**AMENDMENT NO. 4
TO THE
BANKSIA GROVE
AGREED STRUCTURE PLAN NO. 21A**

Title: Banksia Grove Agreed Structure Plan No. 21A
Amendment No. 4

Prepared by: CLE Town Planning + Design

AMENDMENT NO. 4
TO
BANKSIA GROVE AGREED LOCAL STRUCTURE PLAN NO.21A

BANKSIA GROVE
CITY OF WANNEROO
AGREED LOCAL STRUCTURE PLAN No.21A
MAP 2: ZONING PLAN

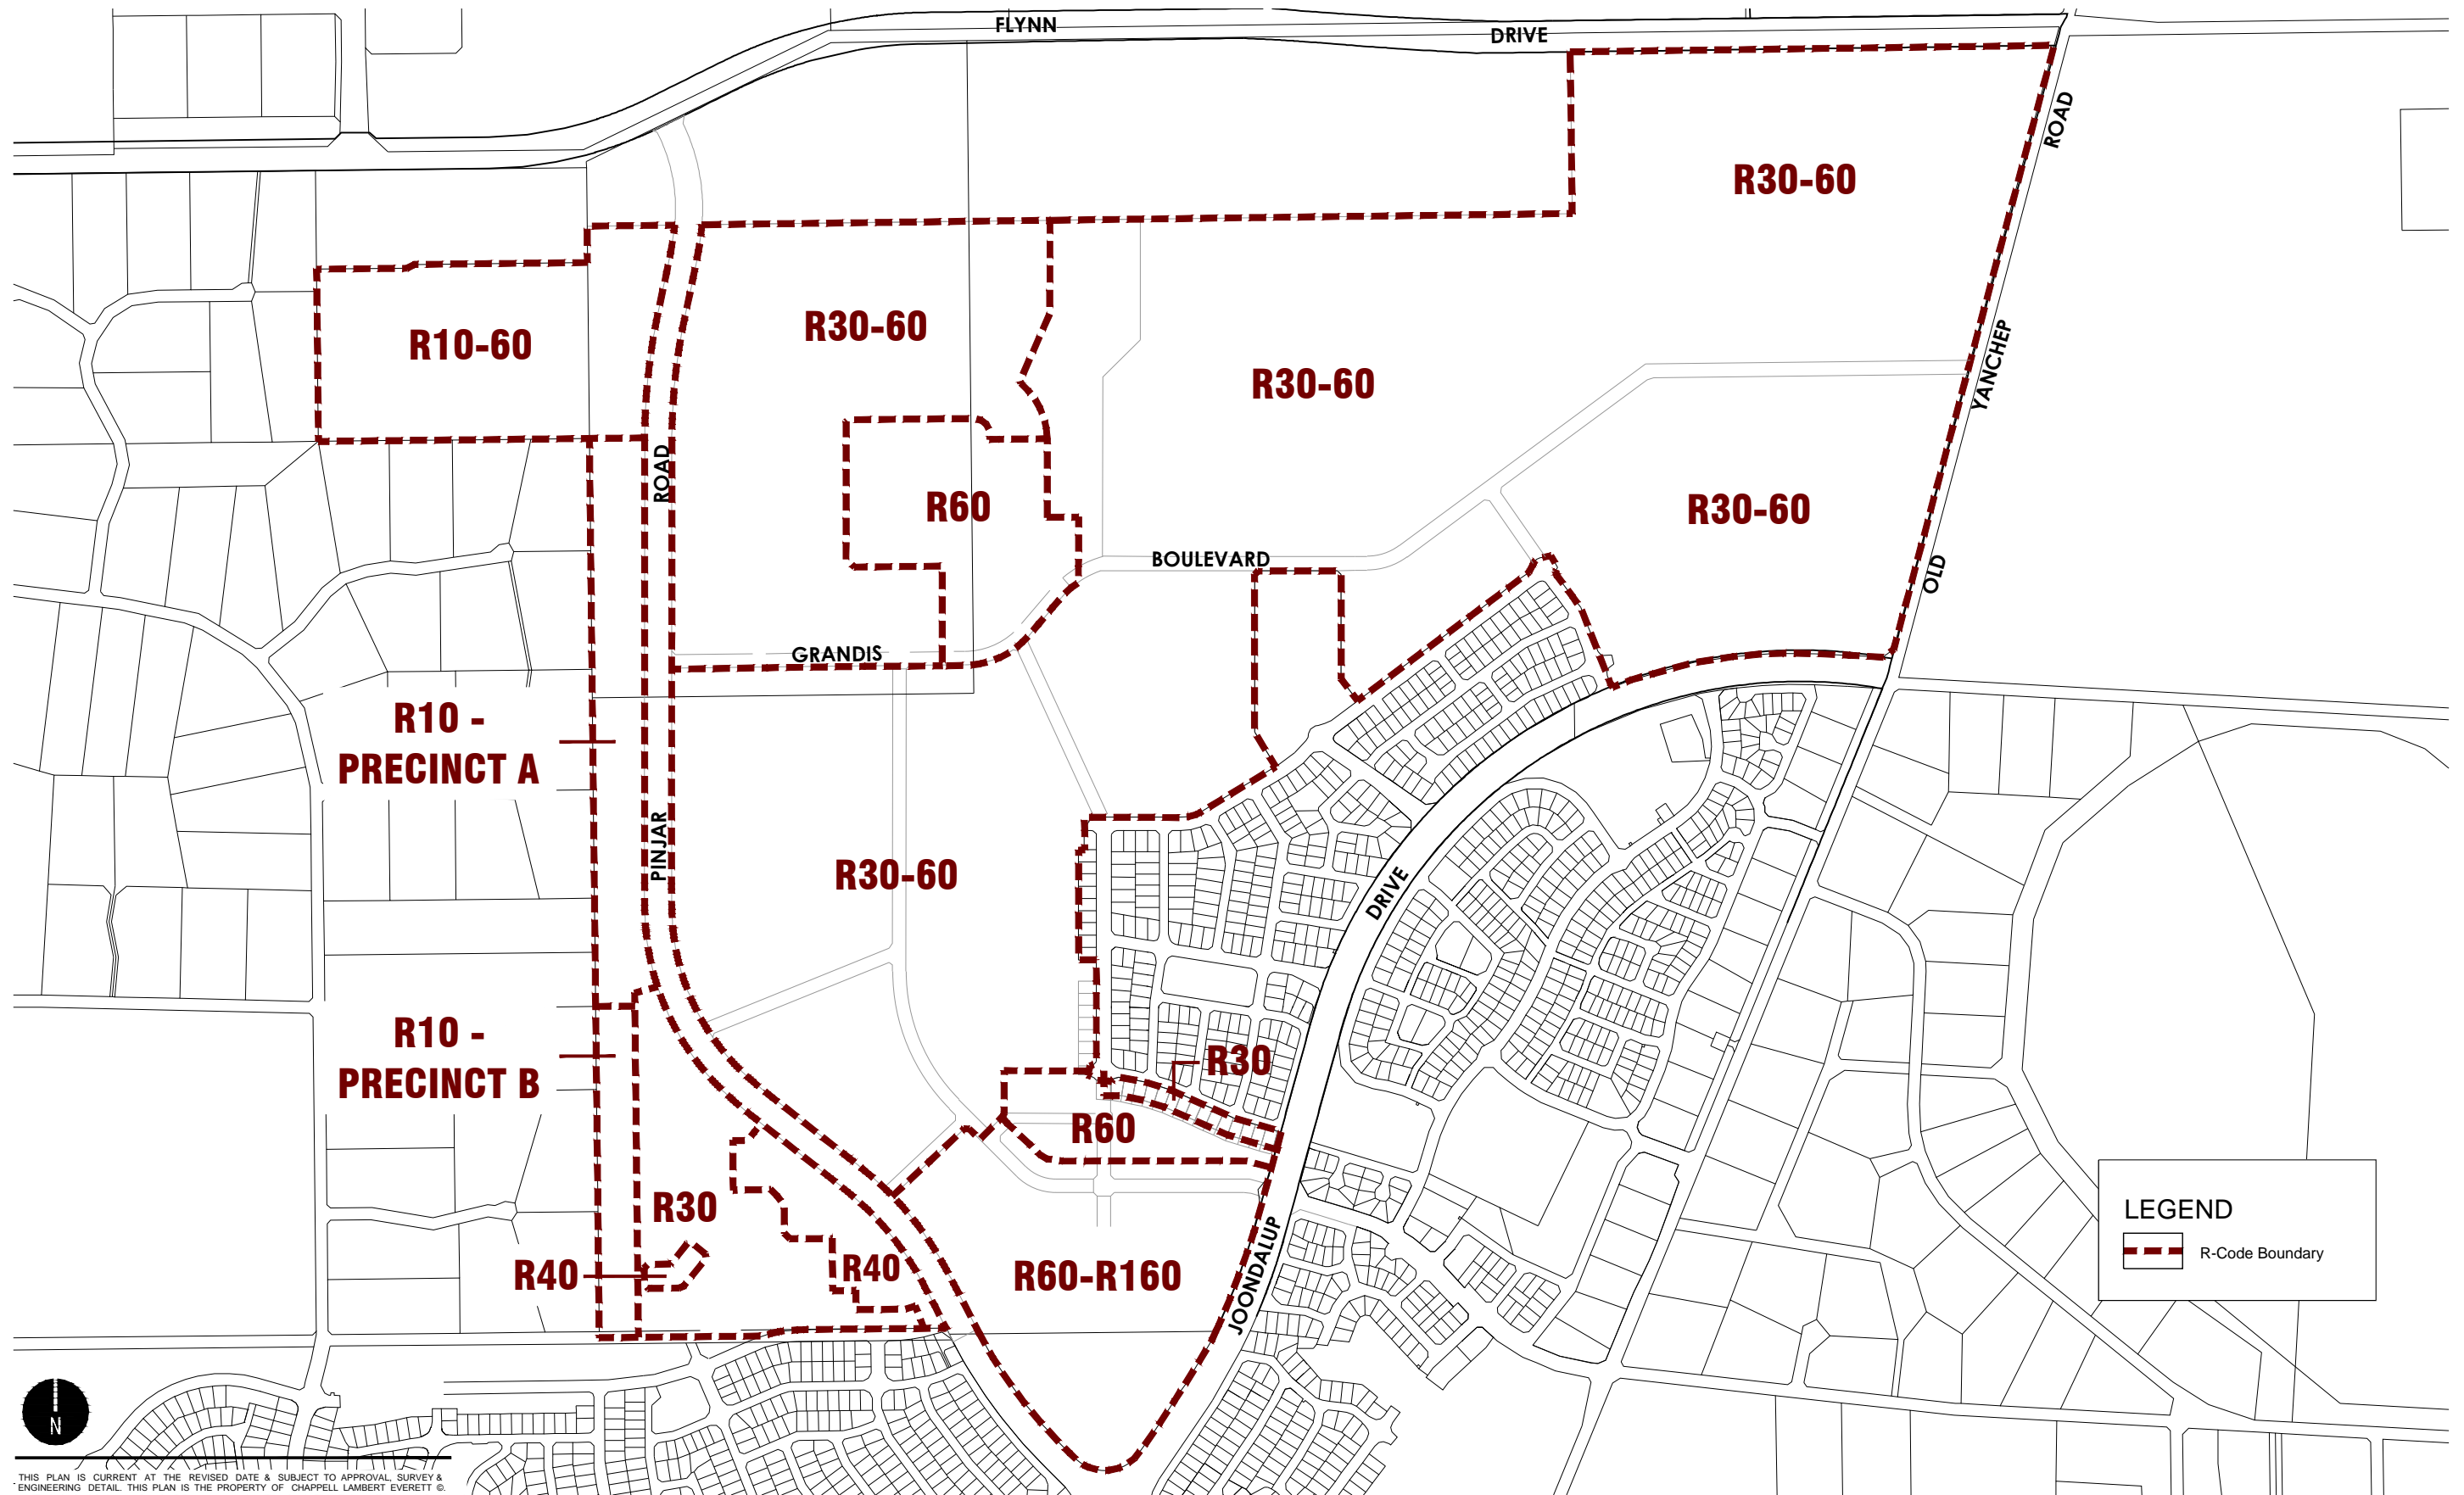
1. Modifying Map 1 'Agreed Local Structure Plan' by rezoning a portion of the 'Special Residential' zone to 'Residential';
2. Modifying Map 2 'Zoning Plan' by rezoning a portion of the 'Special Residential' zone to 'Residential';
3. Modifying Map 3 'R-Code Plan' by recoding a portion the 'Special Residential (SR2)' area from 'Special Residential (SR2)' to 'R10';
4. Modifying Map 3 'R-Code Plan' by creating two sub-precincts of R10 density, namely 'R10-Precinct A' and 'R10-Precinct B';
5. Inserting new text under Clause 8.7 'Development Controls for R10 Coded Lots' into the Part 1 Statutory Planning Section. New text distinguishes 8.7 as being specific to newly created 'R10-Precinct A';
6. Inserting Clause 8.8 'Development Controls for 'R10-Precinct B' Coded Lots' into the Part 1 Statutory Planning Section.

Figure 4 District Planning Scheme No.2 - Proposed

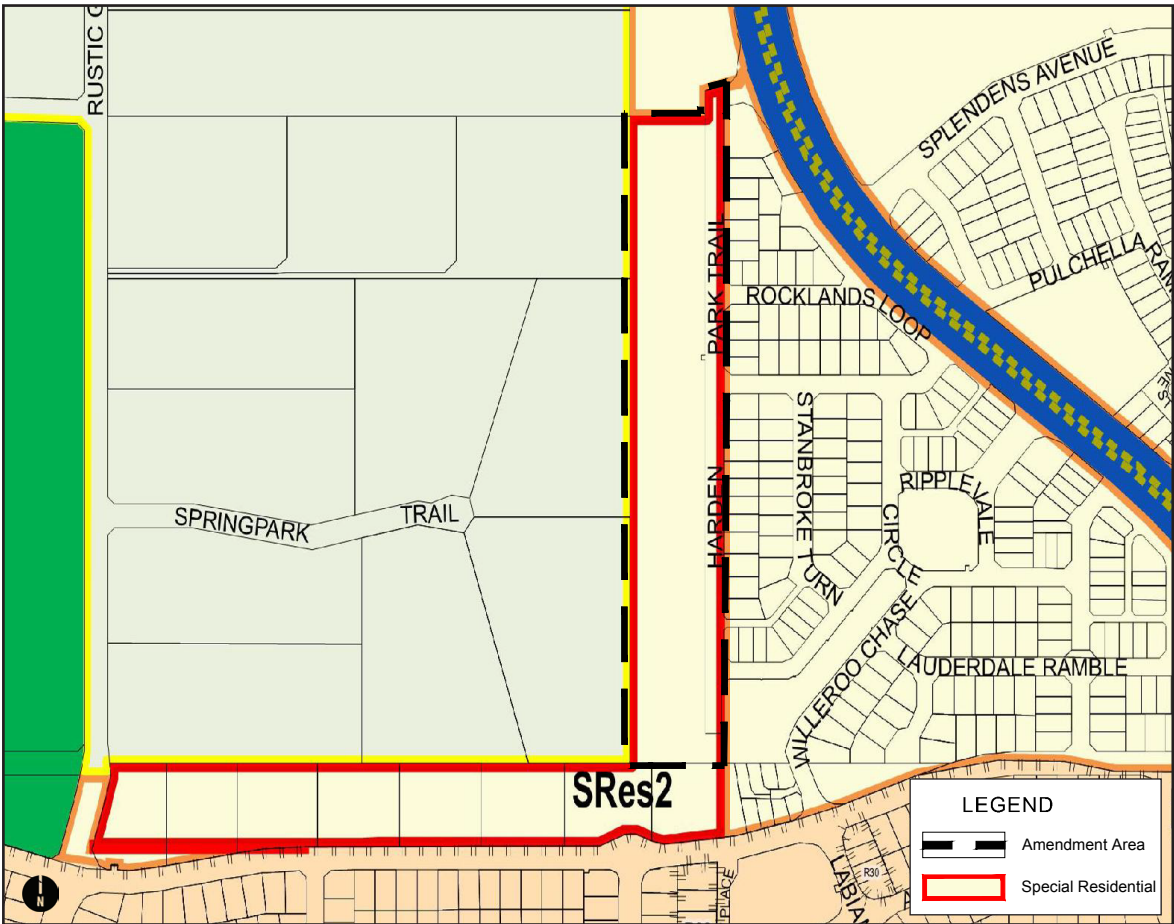
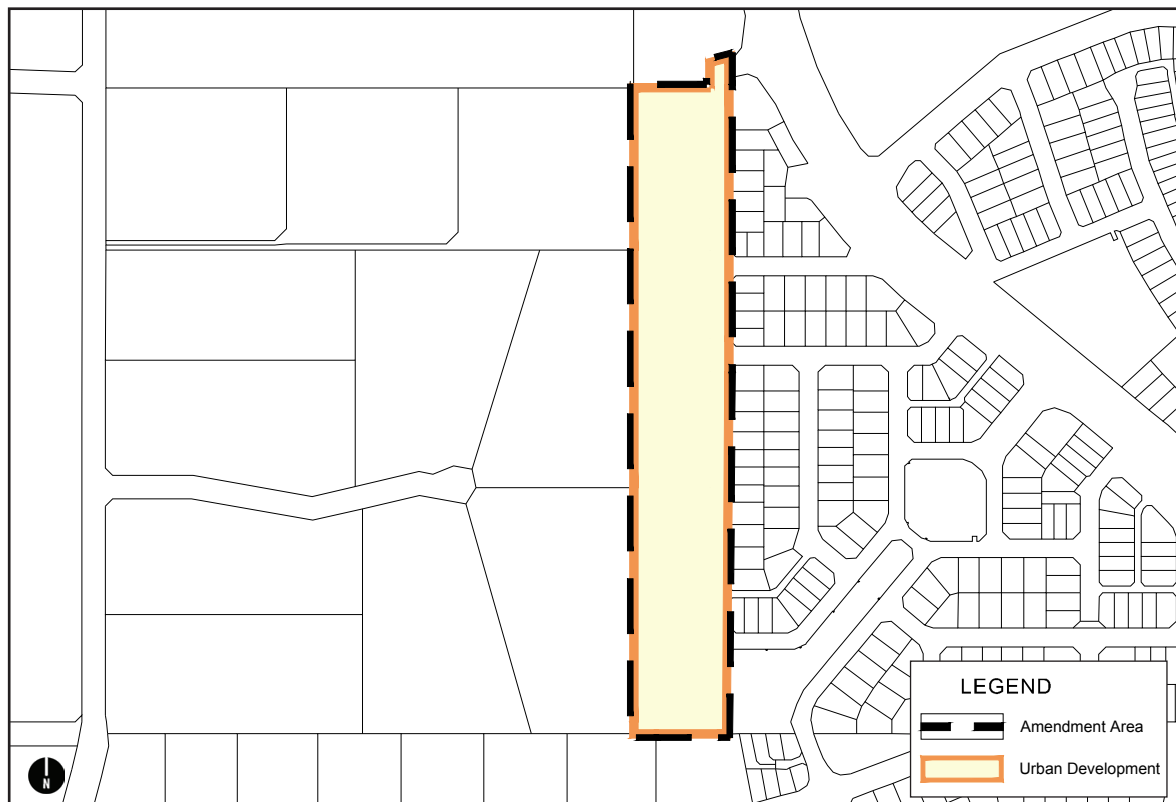
The subdivision and development of the subject land to an R10 density is inconsistent with the current zoning of the land under DPS 2. An amendment to DSP2 is therefore submitted together with this Structure Plan amendment request. The scheme amendment proposes the rezoning of portion of Lot 9190 to 'Urban Development'.
